Executive Director's Recommendation

Commission Meeting: May 3, 2018

PROJECT Security Bollards at the North Entrance Motor Court Jamie L. Whitten Federal Building, United States Department of Agriculture 1400 Jefferson Drive, SW Washington, DC	NCPC FILE NUMBER 7978
SUBMITTED BY United States General Services Administration	NCPC MAP FILE NUMBER 1.41(38.40)44736
REVIEW AUTHORITY Federal Projects in the District per 40 U.S.C. § 8722(b)(1) and (d)	APPLICANT'S REQUEST Approval of preliminary and final site development plans
	PROPOSED ACTION Approve preliminary and final site development plans with comments
	ACTION ITEM TYPE Consent Calendar

NCPC File #: 7978
Jamie L. Whitten Federal Building
Security Bollards at the Motor Court North Entrance

Current Proposal for NCPC Review

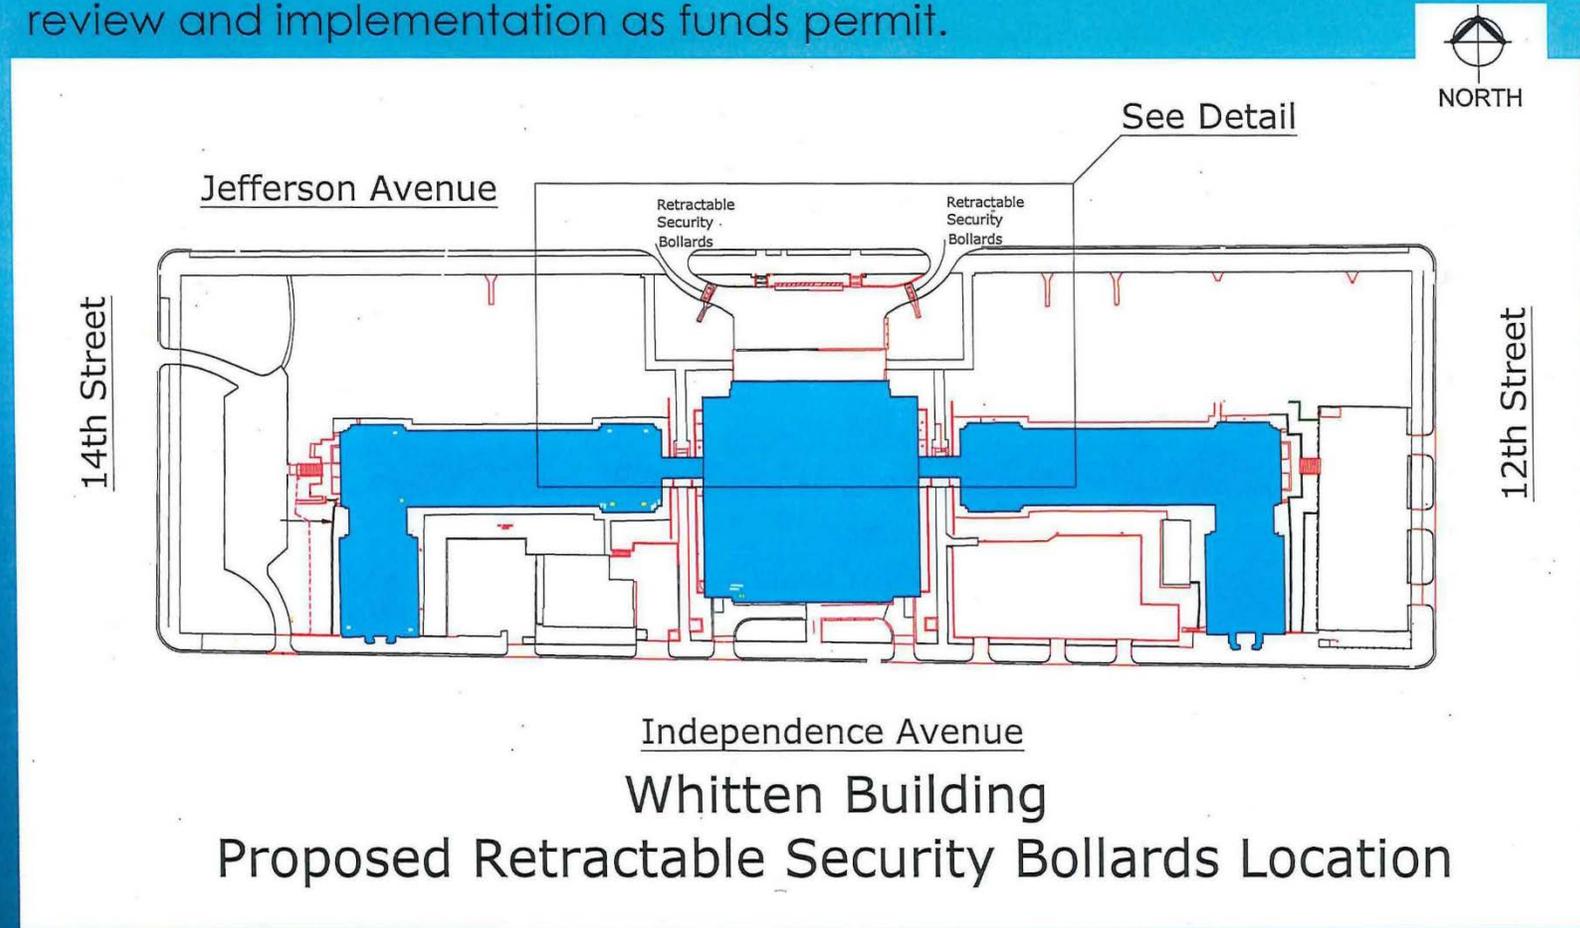
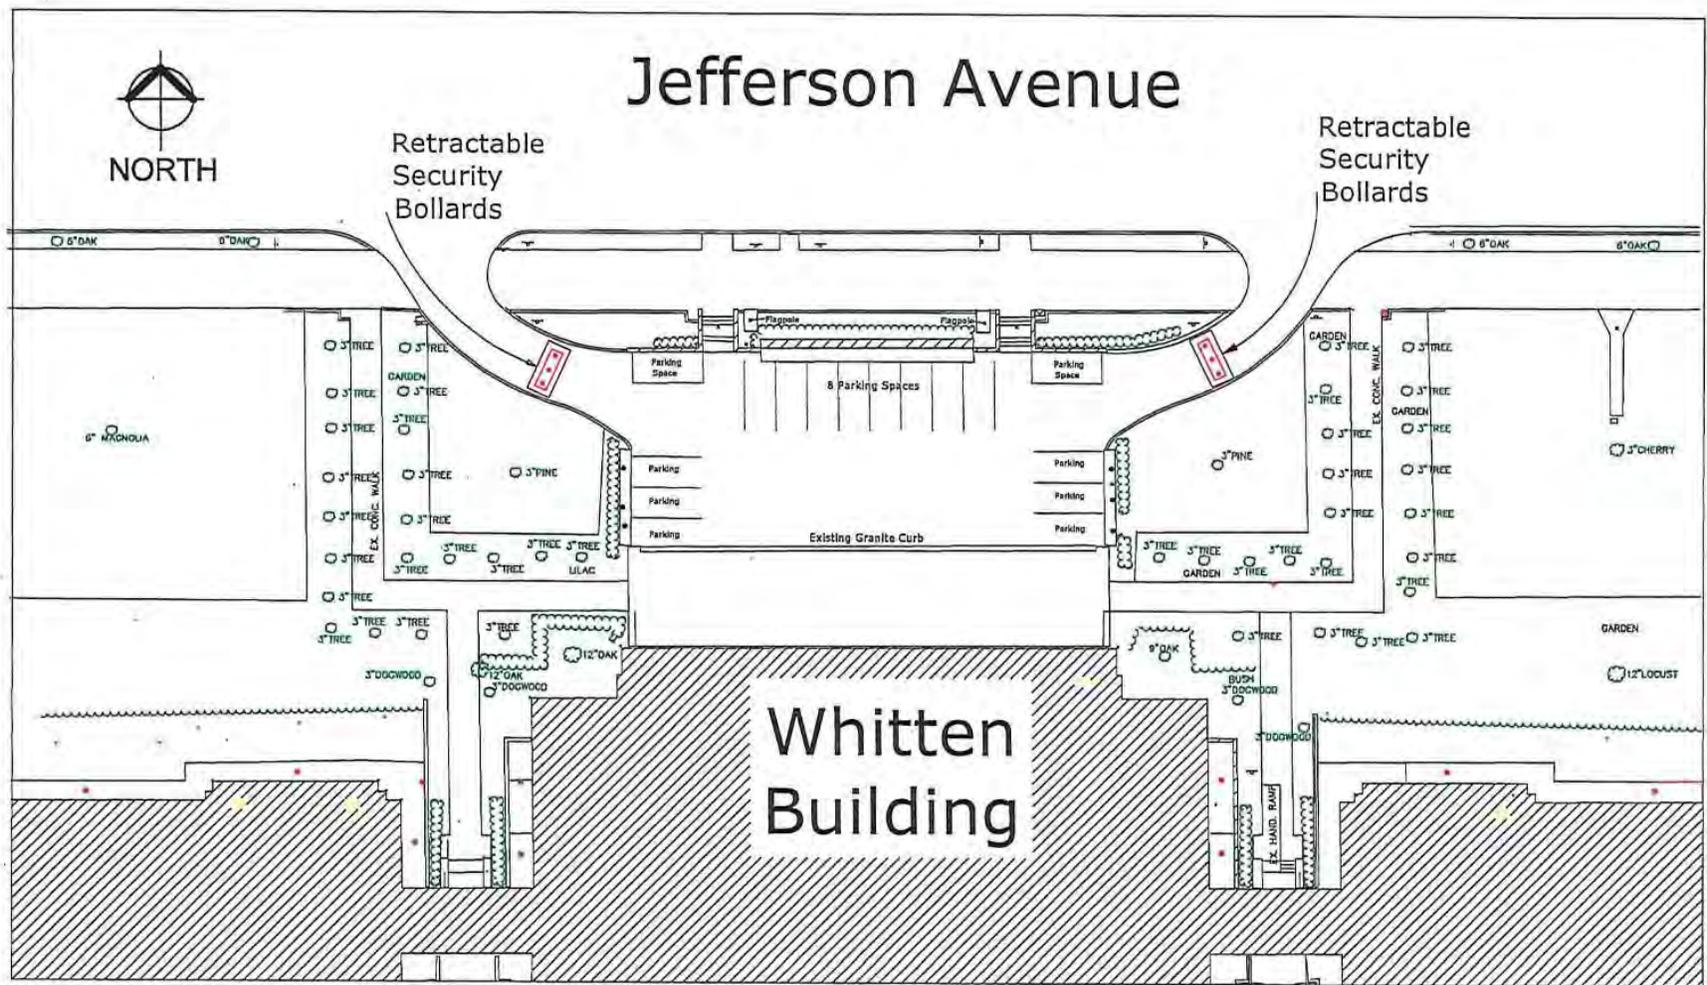
Finds that the proposed security bollards are a visual improvement from the traffic control gates that currently exist at this prominent location.

Notes that the bollards will be wrapped in an interim sleeve of bronze-anodized steel, and that permanent bollard sleeves will be designed when the larger strategy for perimeter security is developed.

Reminds the applicant that the Commission requested that all parking should be eliminated from the motor court along the National Mall in its approval of the People's Garden Site Improvements and Perimeter Security project.

Approves the preliminary and final site development plans for security bollards at the north entrance motor court of the Jamie L. Whitten Federal Building.
